STAFF REPORT: 10-9-2019 MEETING
APPLICATION NUMBER: 19-6490
ADDRESS: 100 SEWARD
HISTORIC DISTRICT: NEW CENTER
APPLICANT: BRAIN HURTIENNE
DATE OF COMPLETE APPLICATION: 9/10/2019
DATE OF STAFF SITE VISIT: 10/1/2019

SCOPE: INSTALL NEW BALCONIES

100 SEWARD REHABILITATION

BALCONY DETAILS

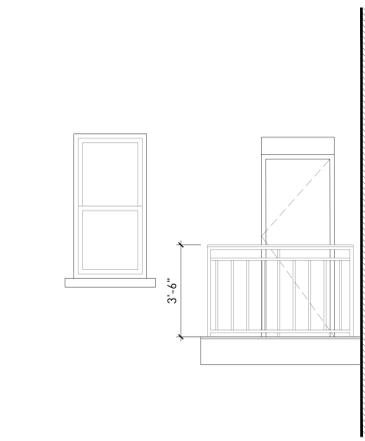
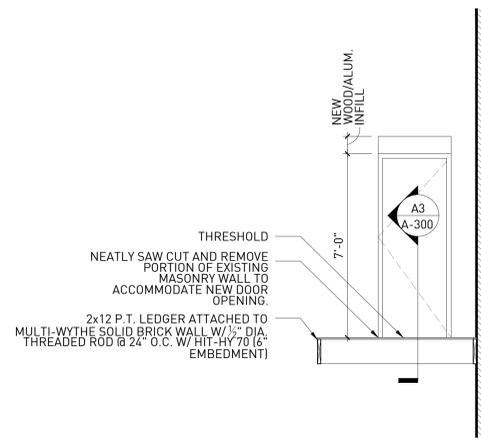
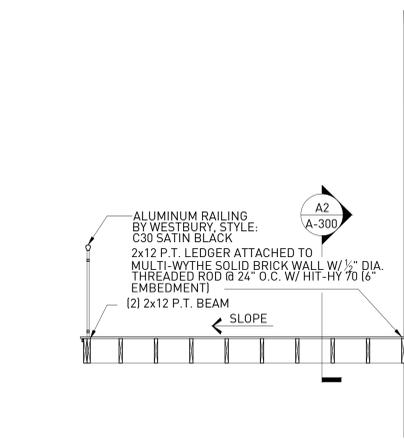
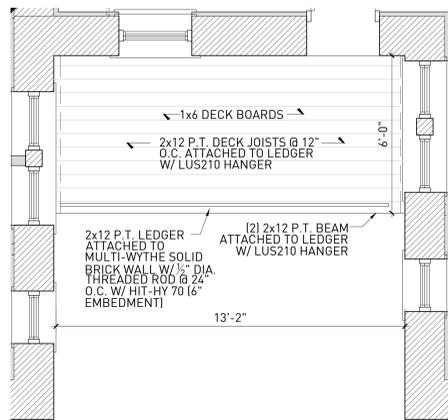
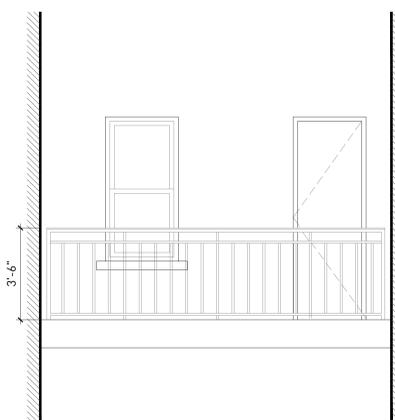
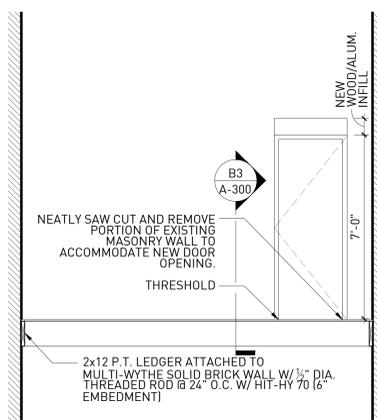
- At each unit, remove one existing window and saw cut brick to lengthen opening in order to accommodate the installation of a new fiberglass single door (color not specified) with glass transom. Each door will lead to a new balcony. The new balcony decks will measure 6'-0" x 12'-4" and will be constructed of wood with wood decking. Each deck will also feature aluminum picket railing which will measure 3'-6" high. The new decks will not be painted.

- The new balconies will not be visible from the public right of-way as they are located within the light wells
- The windows which will be removed and replaced with doorways are not historic age

It is staff's opinion that the work as proposed will not result in the removal of historic materials or the alteration of features and spaces that characterize the property. The work is also compatible with the building's historic character. Staff therefore recommends that the Commission issue a Certificate of Appropriateness for the work as proposed because it meets the Secretary of the Interior Standards for Rehabilitation, standards #2) *The historic character of a property shall be retained and preserved. The removal of historic materials or alteration of features and spaces that characterize a property shall be avoided* and #9) *New additions, exterior alterations, or related new construction shall not destroy historic materials that characterize the property. The new work shall be differentiated from the old and shall be compatible with the massing, size, scale, and architectural features to protect the historic integrity of the property and its environment.* However staff recommends that the Commission issue this COA with the condition that the balconies are either painted or stained a color which matches the buildings trim and that the color of the new fiberglass doors be reviewed and approved by HDC staff prior to the work's initiation.
